# Starter Cable Boot Replacement

# BULLETIN

**Models Affected: All American (A3FE/D3FE/D3RE) with Cummins ISB10 Engine**

S I O S S

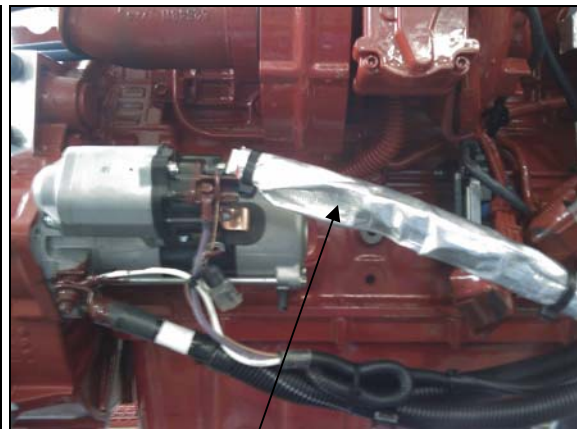
2. Disconnect all negative (black) battery cables first, then all positive (red) battery cables from the batteries.
3. Remove the starter cable (red) from the starter using 11/16" wrench or socket, then remove red rubber boot or silver heat shield from cable.

Red Rubber Boot

Silver Heat Shield

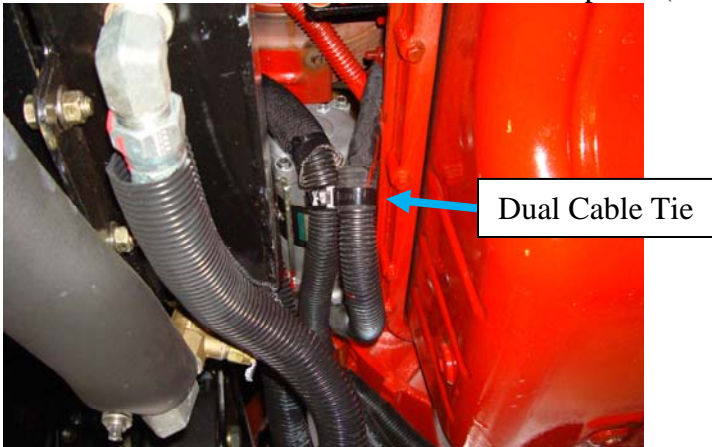
4. Add 11 inches of black heat sleeve (10019602) securing it with cable tie (00029999) away from the terminal.

5. Re-attach starter cable to starter. Apply red enamel glyptal sealant (GE 1201) or equivalent over fasteners for corrosion protection. Be sure cable does not contact turbo shield.
6. Secure starter cable as needed with dual clamp ties (00024043).
